Application No. 09/925,867

Attorney Docket No. 71860

Reply to Office Action of July 14, 2004

**Amendments to the Drawings:**

Fig. 3

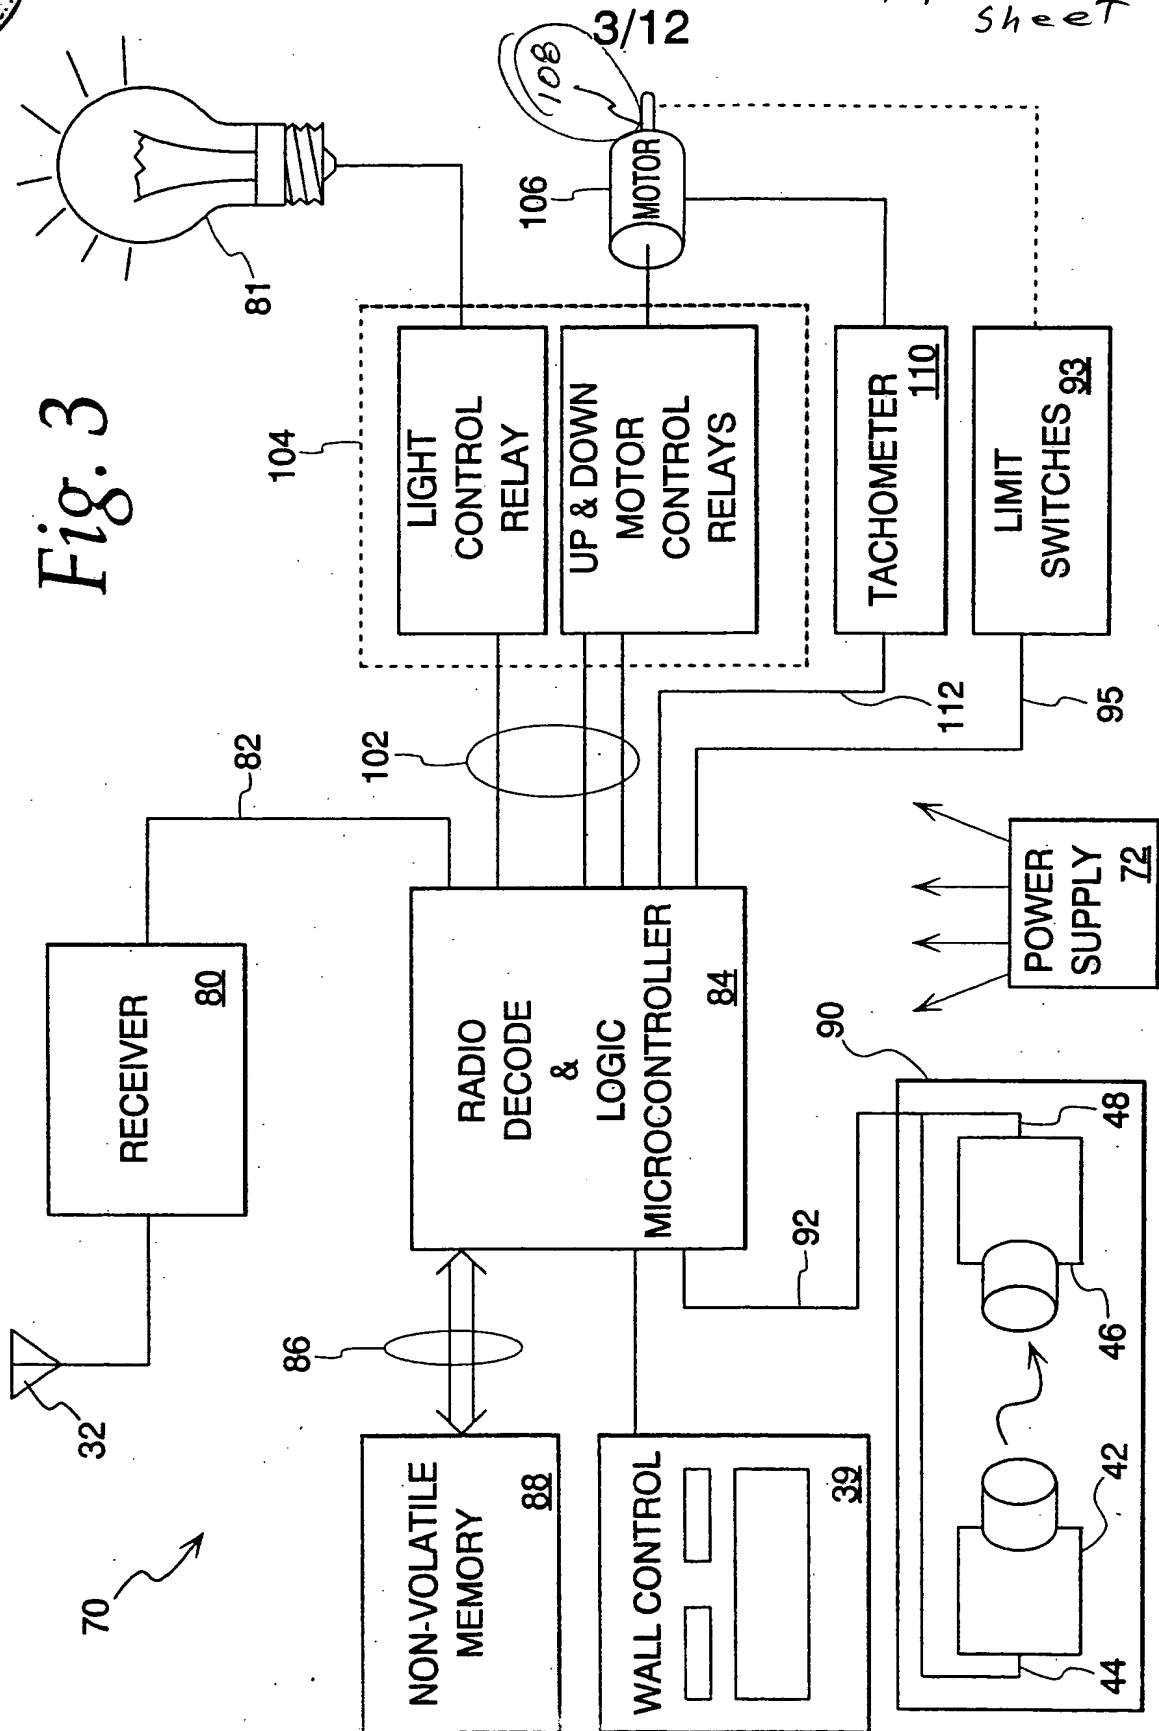
The drawing is also objected to as containing reference characters not shown in the text. The objection to Fig. 1 is corrected by adding the reference numeral 16 to page 5, line 12 of the text. The line 40 of Fig. 2 is referred to at page 5, line 33 of the text. The light 81 of Fig. 3 is already included at page 10, lines 22 and 23 of the text. Fig. 4 is being corrected to delete reference numerals 606, 623, 624 and 630. The lines 82 of Figs. 5 and 6A are already shown in the text at

Fig. 6A

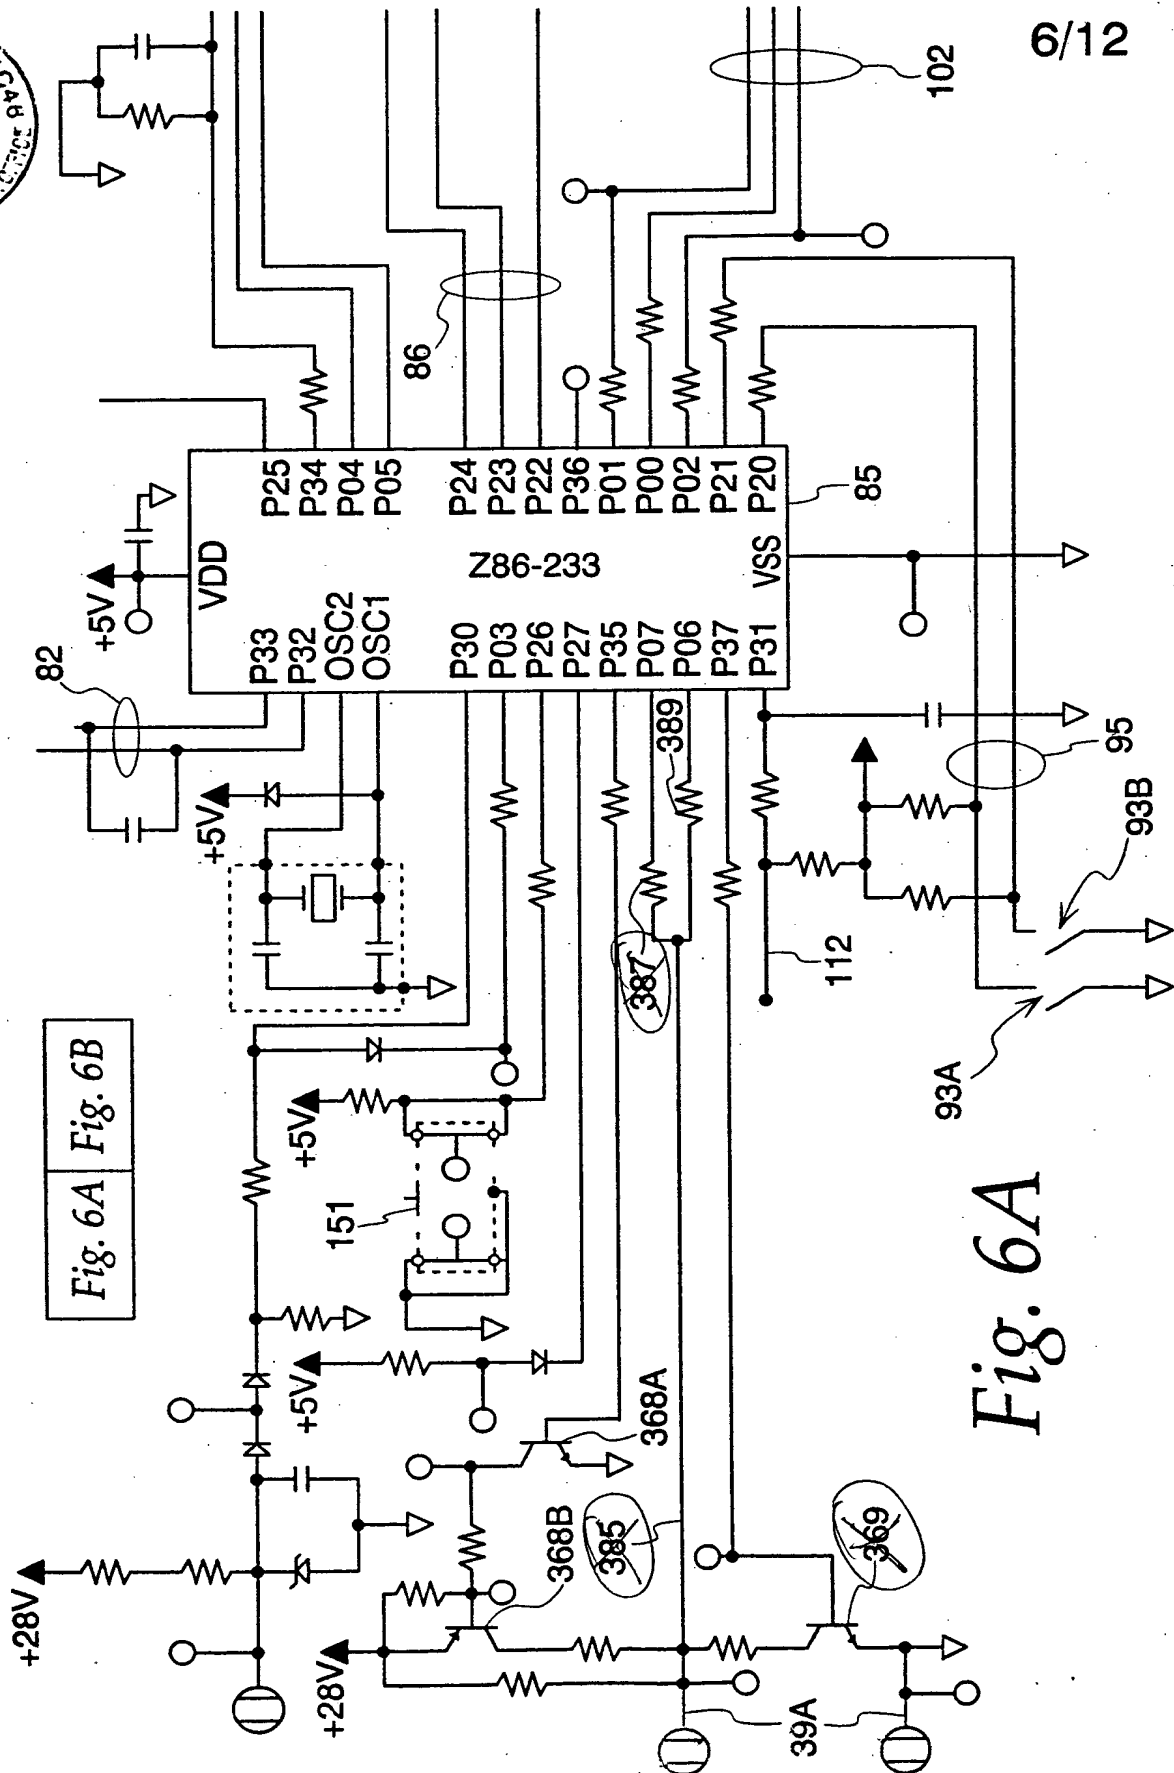
The drawing has been objected to as not including reference characters mentioned in the description. Page 5, line 24 mentions a receiver 80 which is properly referenced in Fig. 2 and no amendments are proposed. Page 5 near line 24 has been changed to correct 39a, 39b, 39c and 39d to 39A, 39B, 39C and 39D for consistency with the drawing. Figure 3 is being corrected to show reference 108 for consistency with page 6, line 39. Reference number 600 is being added to Fig. 4 for consistency with page 7, line 23. Page 9 of the description is being corrected to mention a line 220 which is connected to a coupling capacitor 222 for consistency with Fig. 5. Page 10 of the text is being amended to correct several references having lower case letter to references having upper case letters for drawing consistency. Please note that switch 151 is shown in Fig. 6A.

page 6, line 29. The reference characters 385, 387 and 369 are being removed from Fig. 6A and the relay logic line 102 of Fig. 6A is already discussed at page 6, line 38 of the text. The designation of step 502 is being added to page 8 of the text at line 17 and the reference numeral 508 is being removed from Fig. 8A. Lastly, the second reference character 544 appearing at page 9, line 12 of the text is being changed to 543. Applicant believes that the above noted changes to the text and drawings correct all situations objected to in the drawing by the Examiner.

Fig. 8A

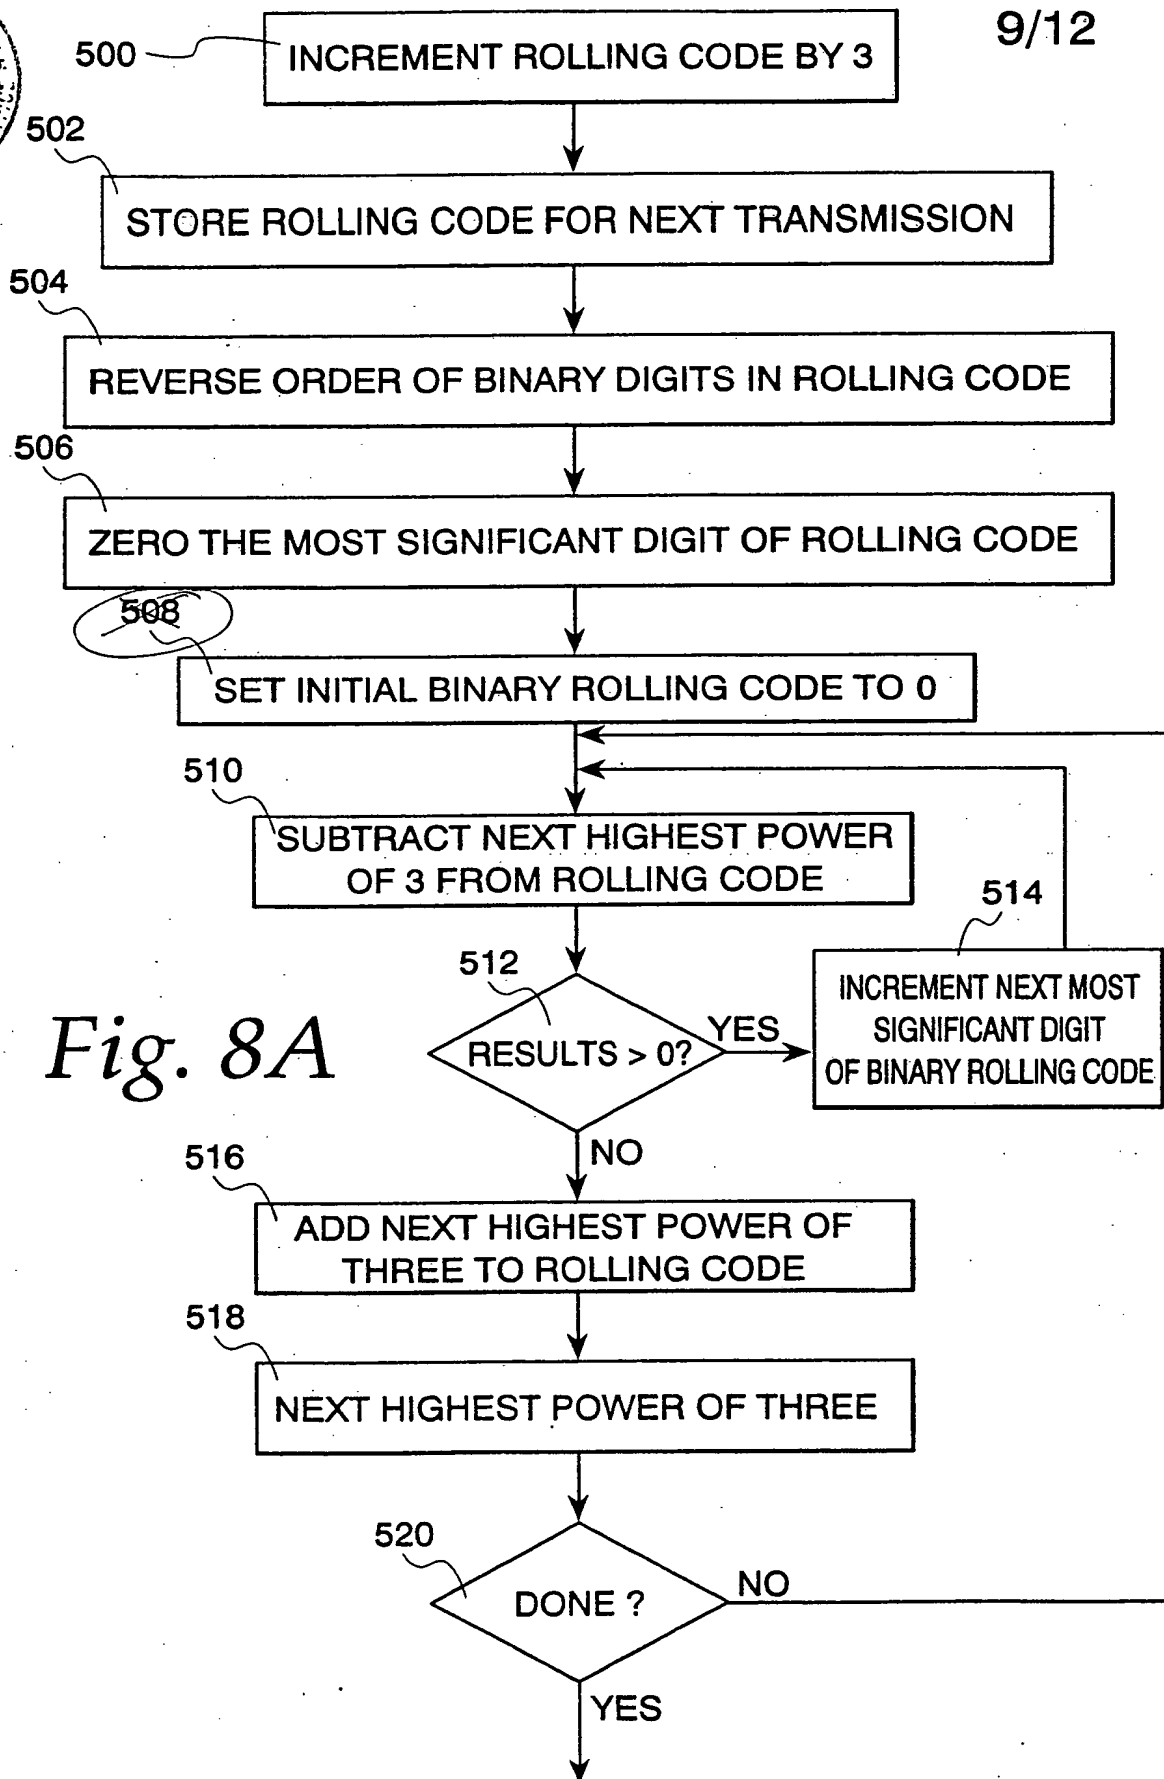
A separate attachment includes a Request for Approval of Proposed Drawing changes of Figs. 3,4,6A and 8A.
